Museum of Contemporary Art

Museum of Contemporary Art
Redevelopment Project
Preferred Project Report

April 2009

Figure 20 Detailed plan of proposed awnings to Level 1 terraces

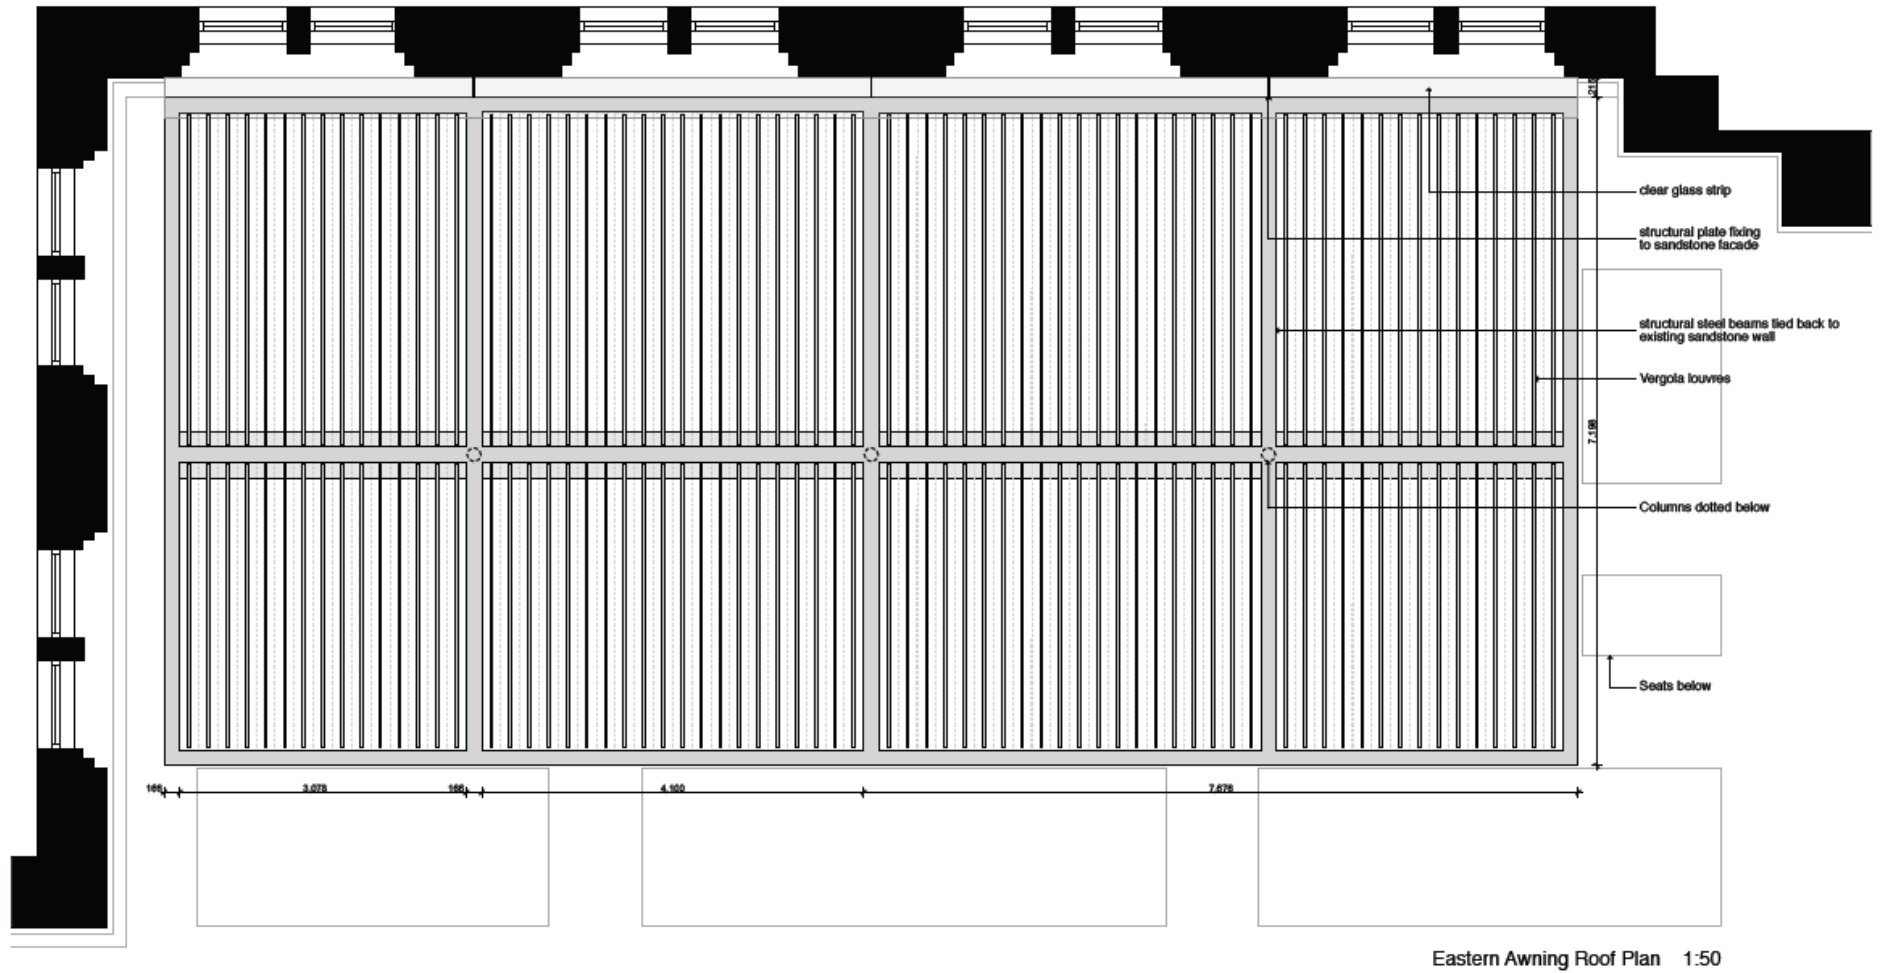
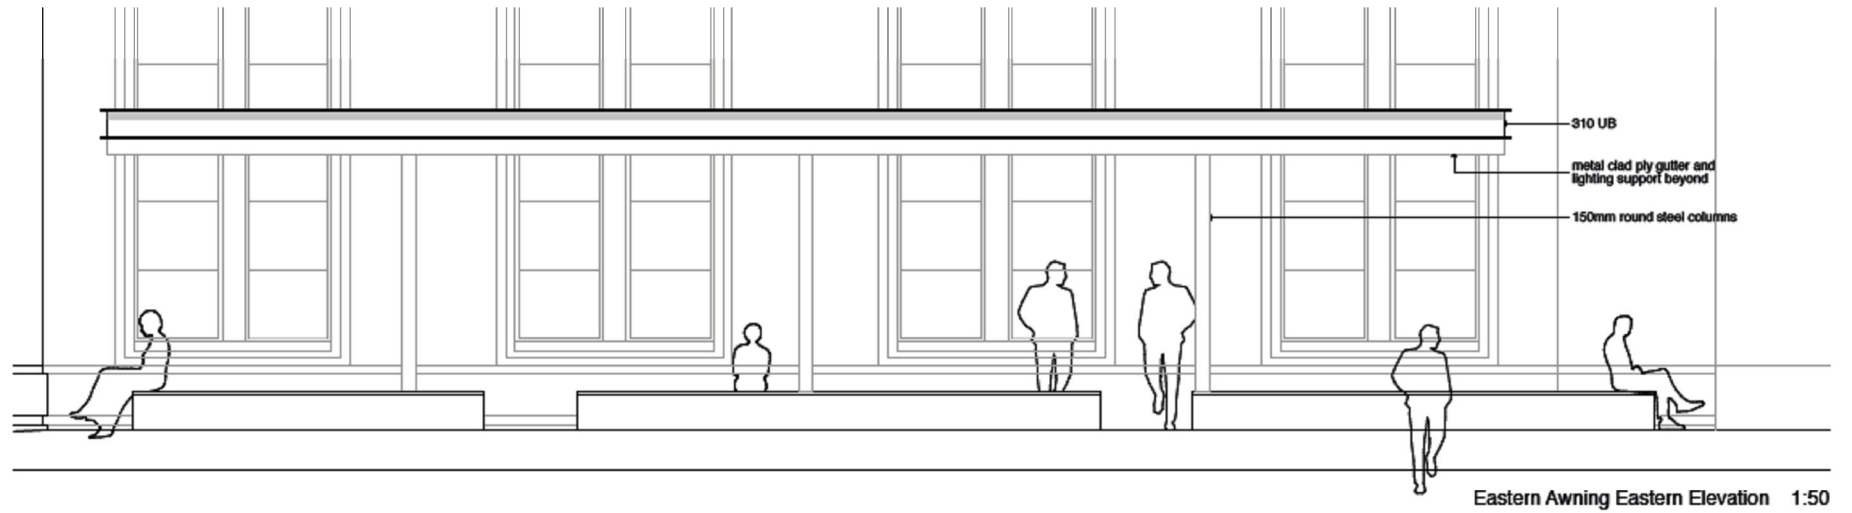
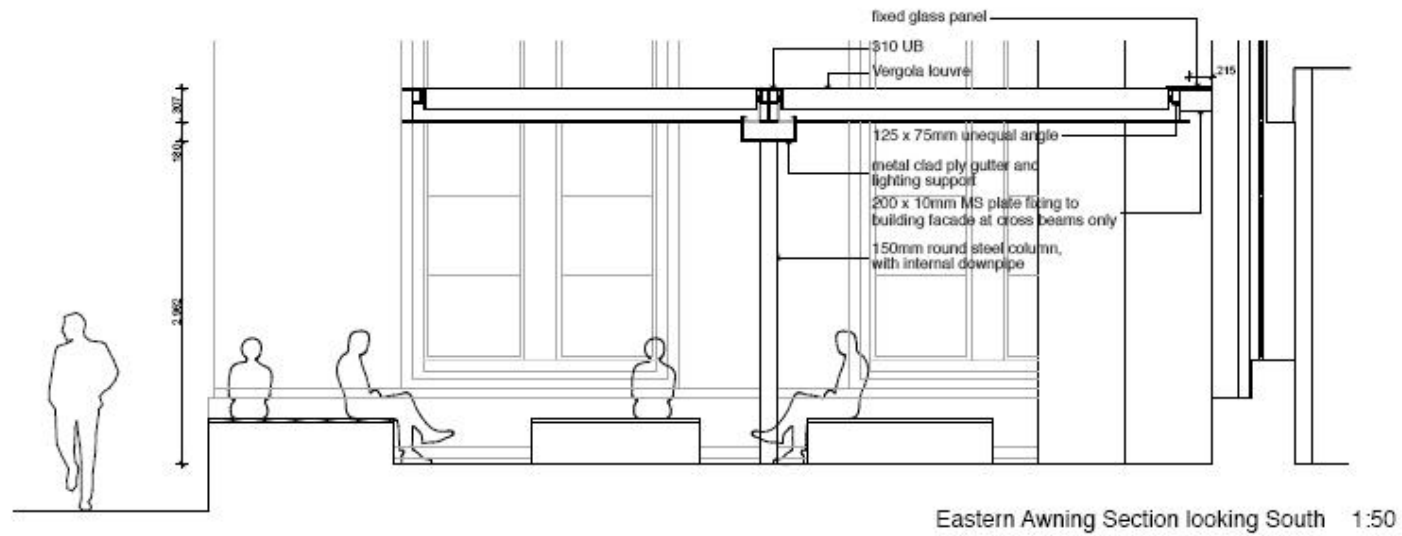
The design detail of the covered areas does not appear to clearly pick up the strong articulation of the existing building. This may be due to the scale of the drawings provided. As requested at our recent meeting a more detailed larger scale drawing of this area should be provided, and consideration may need to be given to design and/or material changes to provide structure(s) that relate appropriately to the existing building.

The MCA's functional requirement is for weather protection to the restaurant dining (Terrace 1.1) and Ambassadors Terrace (Terrace 1.2). To overcome the possibility of messy canvas umbrellas being used, a permanent but lightweight and finely detailed awning was adopted. Detailed plans, elevations and section of these awnings are shown in Figure 20, Figure 21 and Figure 22.

To overcome the possibility of messy canvas umbrellas being used if no awning was provided, a permanent but lightweight and finely detailed awning was adopted. This is considered to be the logical and practical design solution.
